TO: GWRC Hutt Valley Flood Management Subcommittee FROM:: "Save Our Hills" team on behalf of petitioners

**Technical Attachment** (relating to GWRC's Pinehaven Stream study)

1. Case Studies Reveal Discrepancies between GWRC's calculations and Q100 flood maps

The following table of 4 case studies summarises the discrepancies found between GWRC's calculations and maps.

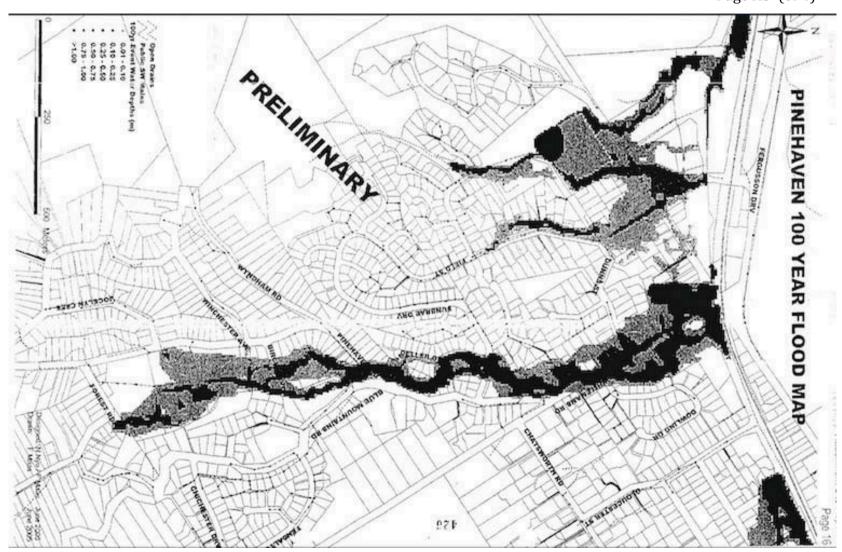
Case Study No:	Case Study Location	The predicted flow at each location according to MWH/GWRC calculations for a 1-in-100 year storm event (includes an allowance for climate change):	The flow shown on GWRC's Q100 flood maps [derived from cross-sectional area m² of actual floodwater (not including freeboard), based on land surveys carried out at each location, divided by assumed flow velocity of 1.0m/s, giving flow in m³/s]	Discrepancy between flood calculations and flood maps:
1	27 Elmslie Road	Approx. 4.8 m <sup>3</sup> /s	Approx. 15.0 m <sup>3</sup> /s	Map shows 3 times the floodwater predicted by MWH/GWRC calculations
2	Dunns Street - at the bottom of catchment	Approx. 25.0 m <sup>3</sup> /s	Approx. 77.0 m <sup>3</sup> /s	Map shows 3 times the floodwater predicted by MWH/GWRC calculations
3	Pinehaven Reserve – middle of catchment	Approx. 16.0 m <sup>3</sup> /s	Approx. 50.0 m <sup>3</sup> /s	Map shows 3 times the floodwater predicted by MWH/GWRC calculations

4	142 Pinehaven Rd – at top of catchment	Approx. 4.7 m <sup>3</sup> /s	Approx. 18+ m³/s	Map shows at least 3 times the floodwater predicted by MWH/GWRC flood calculations

In conclusion, Upper Hutt City Council's preliminary 2005 1-in-100 year flood map (see page A3) appears to us to more accurately show the flows for a 1-in-100 year event predicted by MWH/GWRC's calculations than GWRC;s Q100 flood maps produced in 2010. The 2010 flood maps appear to show grossly inflated flood levels, well above GWRC's own calculated flood levels.
